## ORIGINATION FORM

### Proposed Revisions to a Standard Plans Index (Please provide all information — Incomplete forms will be returned)

Index Number: 653-001  
Sheet Number (s): 1  
Index Title: Pedestrian Control Signal Installation Details

LAST REVISION 11/01/17	DESCRIPTION:	FDOT	FY 2020-21 STANDARD PLANS	PEDESTRIAN CONTROL SIGNAL INSTALLATION DETAILS	INDEX 653-001	SHEET 1 of 1
---------------------------	--------------	------	------------------------------	---	------------------	-----------------

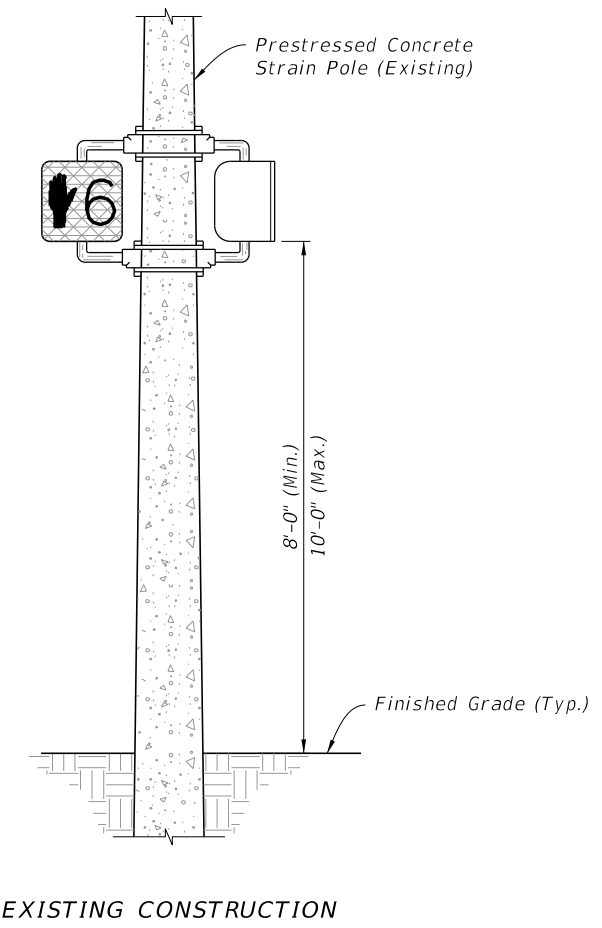
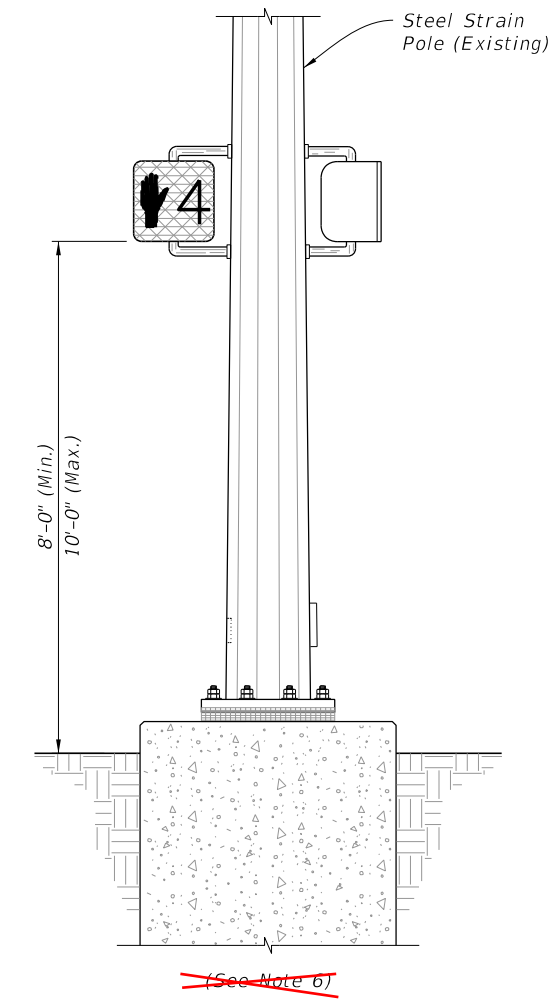
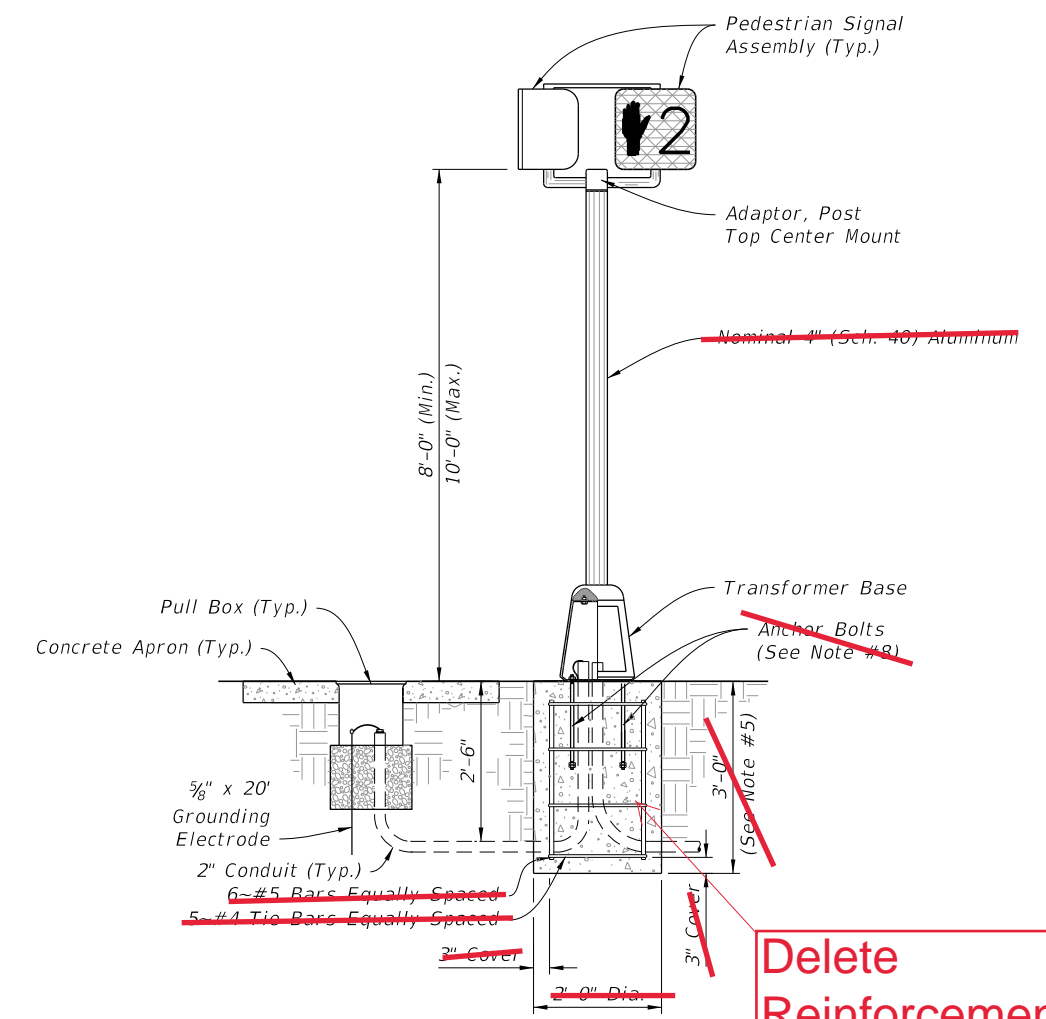
Deleted specific details for the foundation and post of a Pedestal Mounded Pedestrian Signal. The details are moved to a new Standard Plans, Index 646-001.

The Pedestal Mounted Signal support (i.e., post, transformer base, and foundation) are controlled by Specification 646. Therefore, to clarify the requirements of the support details, and which Specification governs the installation and payment, the information is being moved to a new Index 646-001.

Pedestal Assembly details moved to new Index 646-001

NEW CONSTRUCTION  
~~(See Note 7)~~

~~(See Note 6)~~

Delete Reinforcement Details

Added Note 7: For Pedestal Mounted Signal posts and foundations see Index 646-001

Move Existing Notes 5, 8, & 9 to New Index 646-001

LAST REVISION 11/01/20	REVISION	DESCRIPTION:	 FY 2021-22 STANDARD PLANS	PEDESTRIAN CONTROL SIGNAL INSTALLATION DETAILS	INDEX 653-001	SHEET 1 of 1
---------------------------	----------	--------------	----------------------------------	---	------------------	-----------------

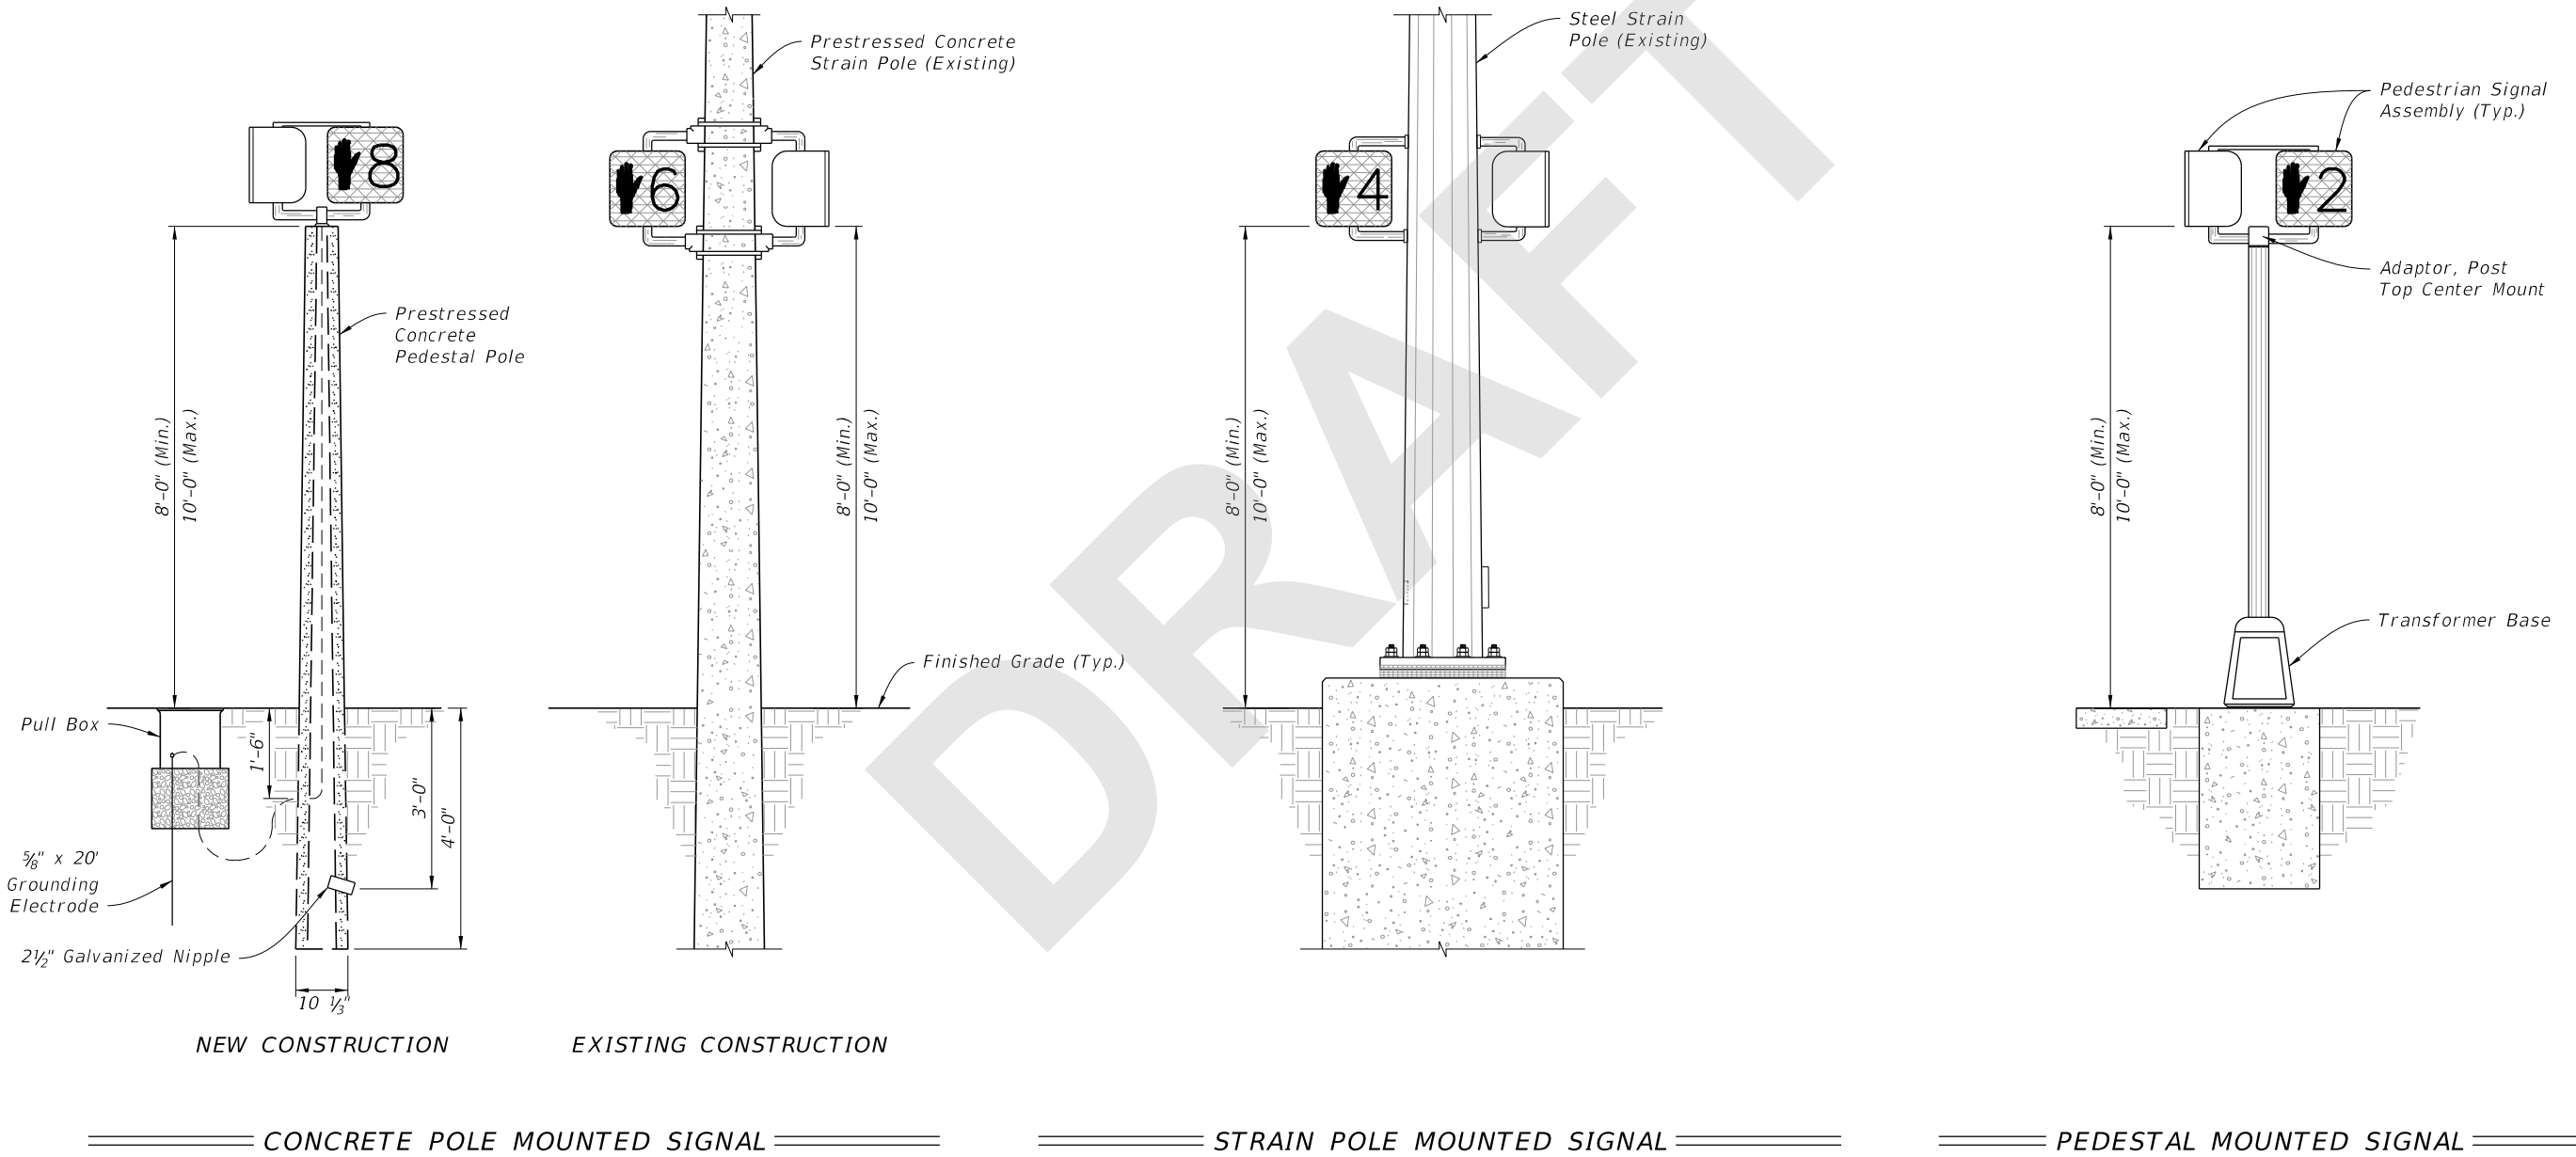
1. As an option, pedestrian signals may be installed on concrete poles and pedestals using lead anchors (two bolts same size per hub) in lieu of the stainless steel bands.
2. Repair drilled or punched holes in galvanized steel poles or pedestals in accordance with Specification 562. Install grommets or bushings in each hole.
3. Meet grounding requirements of Specification 620.
4. See APL for Department-approved Pedestrian Signal Assemblies and hardware.
5. For Prestressed Concrete Poles see Index 641-010.
6. For Steel Strain Poles see Index 649-010.
7. For Pedestal Mounted Signal posts and foundations see Index 646-001
